# **Appendix 1-C Scott Valley Comment Response Summary**

**Scott Valley Groundwater  
Sustainability Plan Public  
Comment Summary**

Siskiyou County Flood Control and  
Water Conservation District

Stantec Consulting Services, Inc.

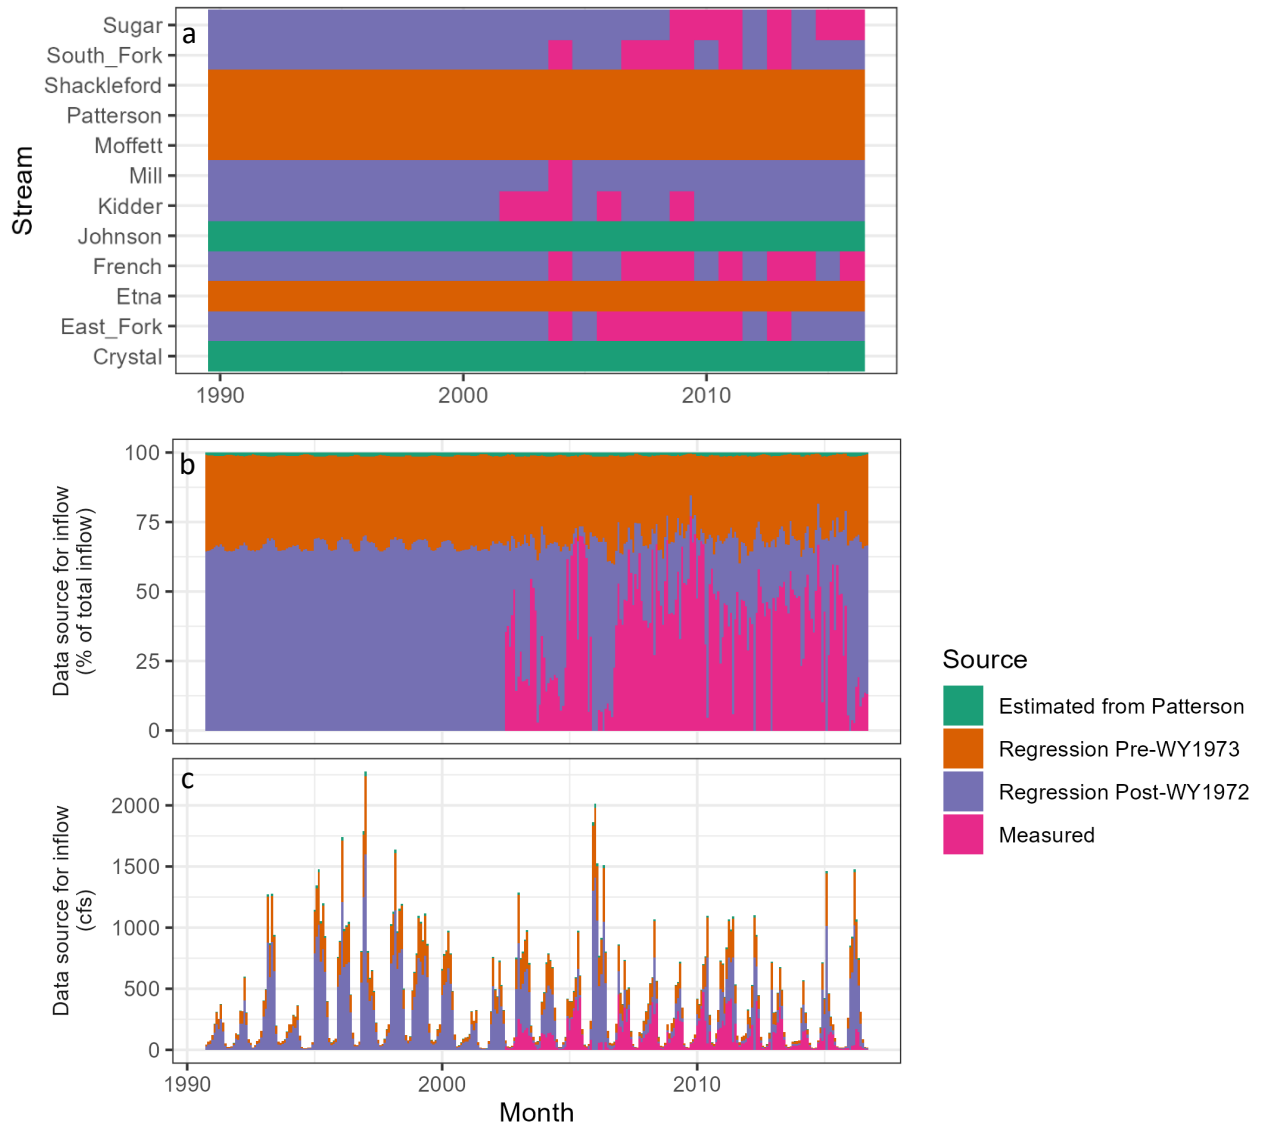
The first thing to recognize about the gap-filling is that gaps are substantial (Figure 2a), so the methods for filling them matters. For the current SGMA GSP, the SVIHM was run for WY1991–2018. Prior to WY 2002, all (100%) of tributaries were estimated using regression against the USGS gage. Since WY 2002, additional gages have been installed but most were operated in only a subset of recent years and now only Sugar Creek and French Creek are still operational (Figure 2). The version of SVIHM used for SGMA did not use any tributary data for 2017–2018. The percent of total estimated inflows in a month that are based on measurements (i.e., gages) only sporadically exceeds 50% (Figure 2b, 2c). The USGS 11519500 gage that is the source for all the regression-based estimates is located at the outlet of Scott Valley. It is problematic to use a gage that is the surface water output of a groundwater basin to estimate the surface water inputs to the same basin, because that groundwater basin exerts profound natural and human influences on hydrology, including water diversions, groundwater pumping, evapotranspiration, groundwater recharge, and leakage of groundwater to streams. In reality, these influences vary not only seasonally (e.g., spring vs. fall) but also inter-annually (i.e., wet years vs. dry years), but using linear regression assumes a constant relationship between the input and output. For example, long-term management changes can affect the relationship between inflows and outflows (i.e., see Figure 1a showing effects of increased groundwater extraction). This gage is also used for calibration and verification of the SVIHM. Given that inflows are an important driver of groundwater dynamics, using the outflow to estimate inflows may artificially inflate the apparent accuracy of the SVIHM (because estimated inflows are automatically scaled based on measured outflows).

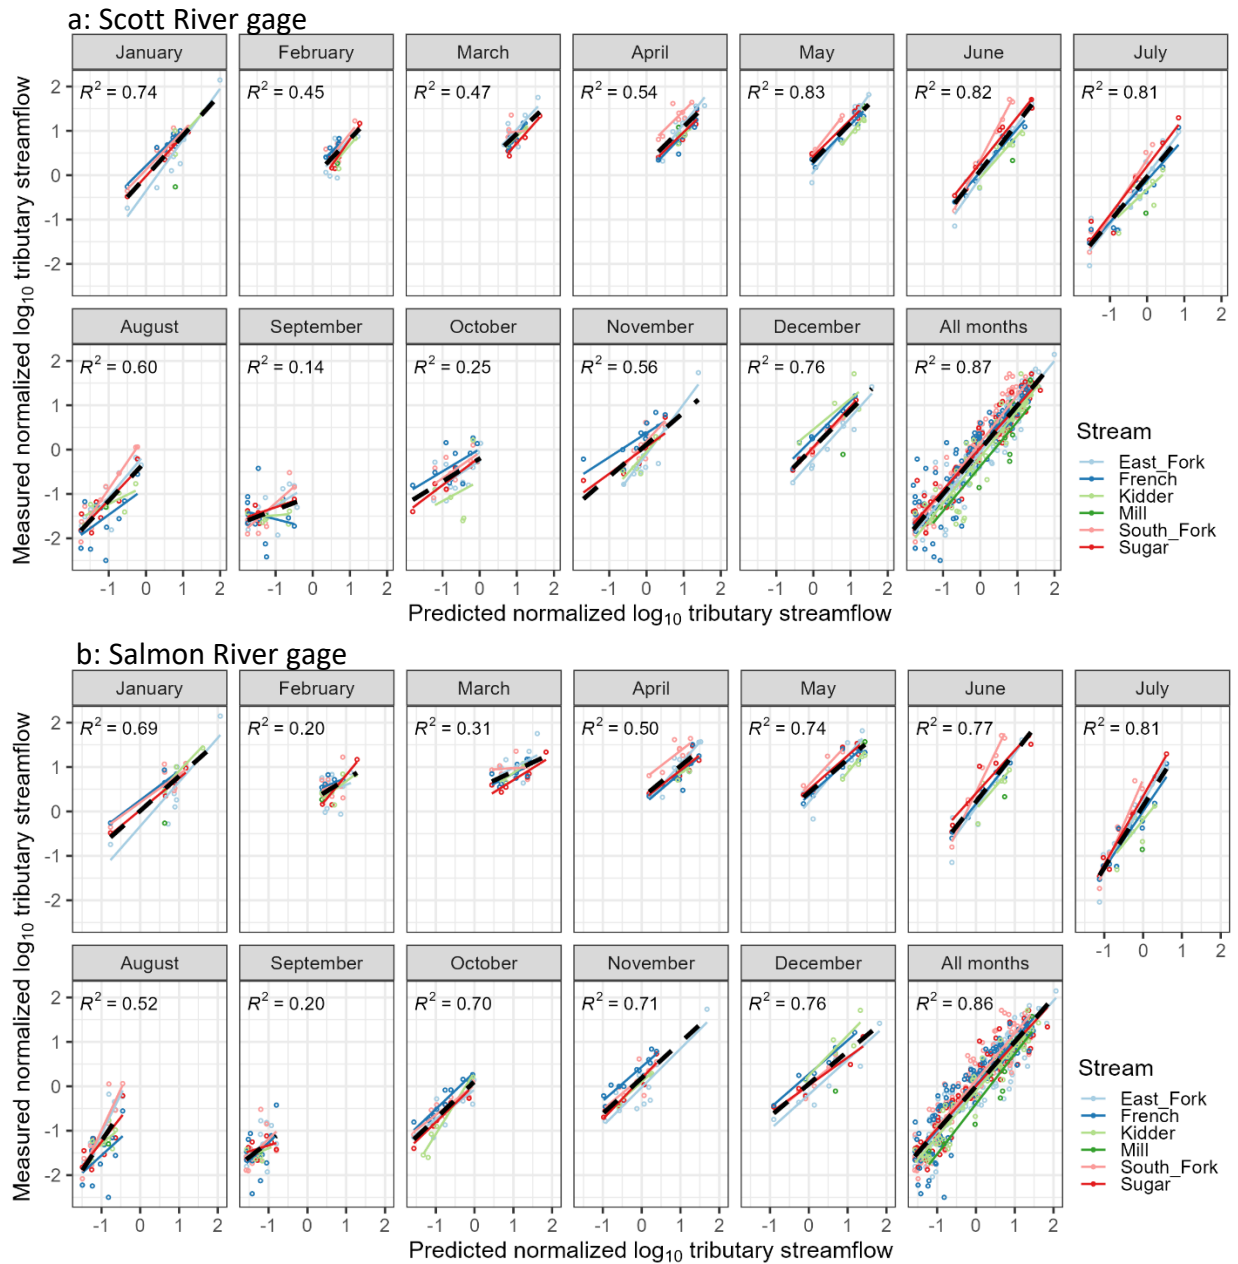
immediately to west) to the Scott River sub-basin, lack of dam regulation, lack of major diversions, and does not contain a large alluvial groundwater basin with intensive groundwater extraction. The Salmon River's relative lack of diversions and groundwater extraction may make it a better choice than the Scott River during the low-flow season. While overall fit for the WY 1973–2016 period is similar for Scott River gage model ( $R^2 = 0.87$ ) and Salmon River gage model ( $R^2 = 0.86$ ), fit varies by month with the Scott River performing better (i.e., higher  $R^2$ , Figure 3b) in January–August and the Salmon River model performing better in September–November (i.e.,  $R^2 = 0.20, 0.70, \text{ and } 0.71$  compared to  $R^2 = 0.14, 0.25, \text{ and } 0.56$ )(Figure 3). Differences are especially strong in October, with  $R^2 = 0.70$  for the Salmon River model compared to  $R^2 = 0.25$  for Scott River model (Figure 3). Based on this evaluation, we recommend using the Salmon River model to fill tributary flow gaps in the months of September–November, which is the period when the groundwater basin begins filling and flows begin rising in response to increased precipitation and decreased evapotranspiration following the hot dry summer and year's lowest flows. This period is biologically important because it coincides with the start of chinook salmon spawning season. We are unclear on how poorly the fit of the Scott River regression model during this period (Figure 3a) affects the simulation of groundwater dynamics and outflows in the SVIHM. Have any sensitivity analyses been conducted to see how sensitive outflows are to inflows during this period?

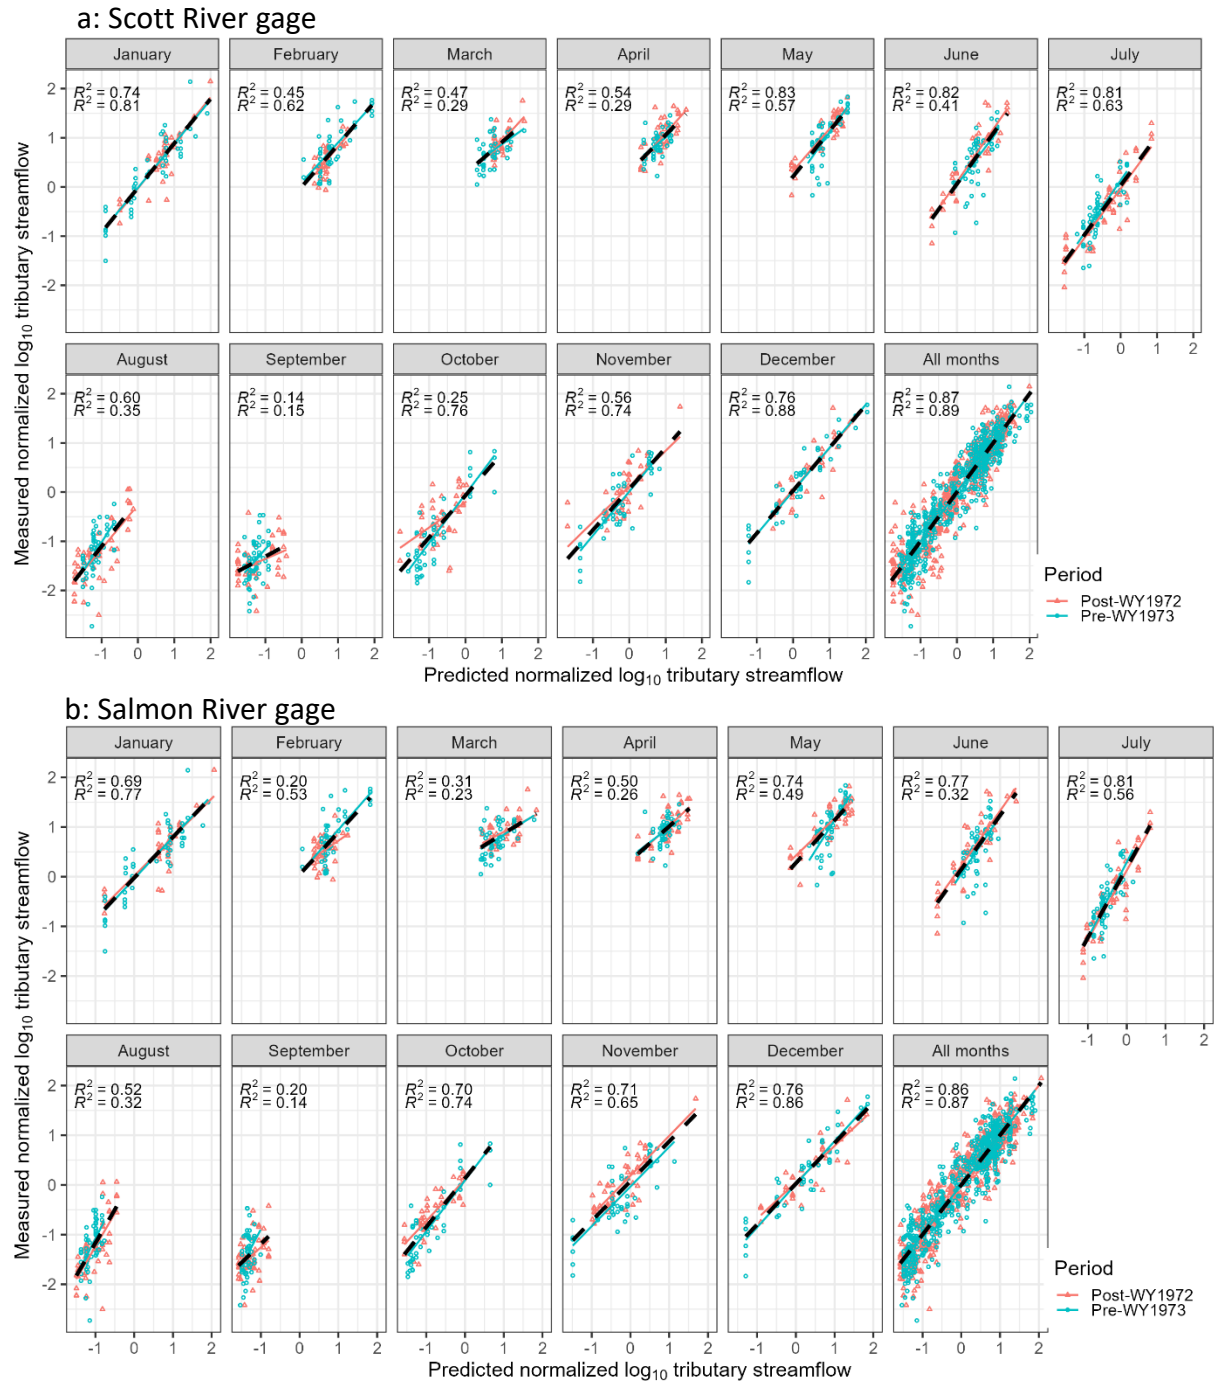
In contrast to the major differences in the relationships between tributaries flows and Scott River flows for the WY 1957–1972 and WY 1973–2016 periods (Figure 1a), there appears to be no difference between the periods when the Salmon River gage is used instead (Figure 1b). The lack of difference between these periods in the Salmon River models suggests that for tributaries that have no post-1972 flow data (i.e., Shackelford, Patterson, and Etna creeks)(Figure 2a), it is likely better to use the Salmon River model for gap-filling additional months (i.e., maybe June–December for these tributaries, instead of the September–November we are recommending for the other tributaries?). The recommendation for June–December is based on the observation that the between-period divergence occurs at normalized  $\log_{10}$  Scott River flows less than zero (Figure 1a) and in the WY 1973–2016 period such flows tend to occur more frequently in June–December than other months (Figure 4a).

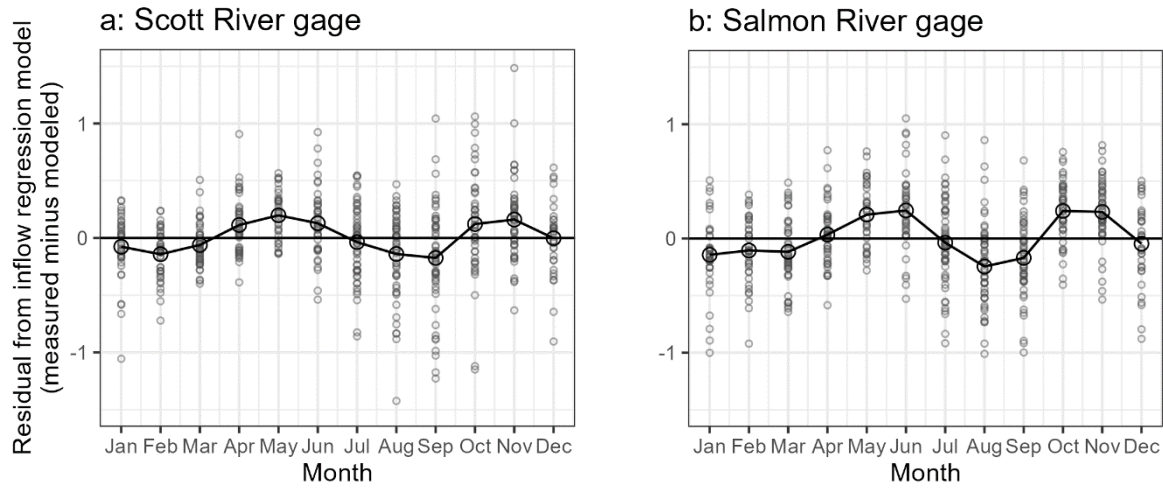
One additional suggestion for potential additional refinements to the methods for filling data gaps that we do not currently have time to test, but want to mention here so it could potentially be followed up on later, is to use hierarchical models and account for watershed area. The SVIHM's normalization (a.k.a. "standardizing", our preferred term) of the flow data (subtracting the mean and dividing by standard deviation, with the mean and standard deviation calculated individually for each site based on that site's period of record) is intended to allow all tributaries to be included together in the same regression model. However, we have some concerns that for sites with short records (e.g., 11 months at Mill Creek, 6 months at Etna and Patterson creeks), there are far too few data points for the mean and standard deviation to be representative of long-term patterns, which could lead to artifacts in the regression outputs. A possibly more robust alternative would be to instead convert the flow data to specific discharge (i.e., flow per watershed area in units of cfs/mi<sup>2</sup> or its metric areal equivalent mm/d), then standardizing by subtracting the mean and dividing by standard deviation (with the mean and standard deviation calculated from the entire pool of specific discharges from all sites, rather than calculating the mean and standard deviation only from each site's period of record). From these standardized specific discharges, a single hierarchical model (a.k.a. mixed effects model) could be constructed with appropriate random effects to explicitly account for inter-site differences. R packages available for implementing such models include 'mgcv', 'lme4', and 'nlme'. A hierarchical model could help account for inter-site differences. For example, not surprisingly given its the relatively low elevation watershed, Moffett Creek appears to have a greater percent of its annual flow occur during January–March than other tributaries and then a lesser percent of its annual flow occurs during May–June snowmelt runoff (not shown here). There are clear, albeit relatively small, seasonal patterns in the residuals (calculated as measured minus modeled) in both the Scott River and Salmon River regression models, with both models under-predicting tributary flows in May–June and October–November underpredicting tributary flows in January–March and August–September (Figure 5). A hierarchical model would likely help remove the seasonal patterns in model residuals.
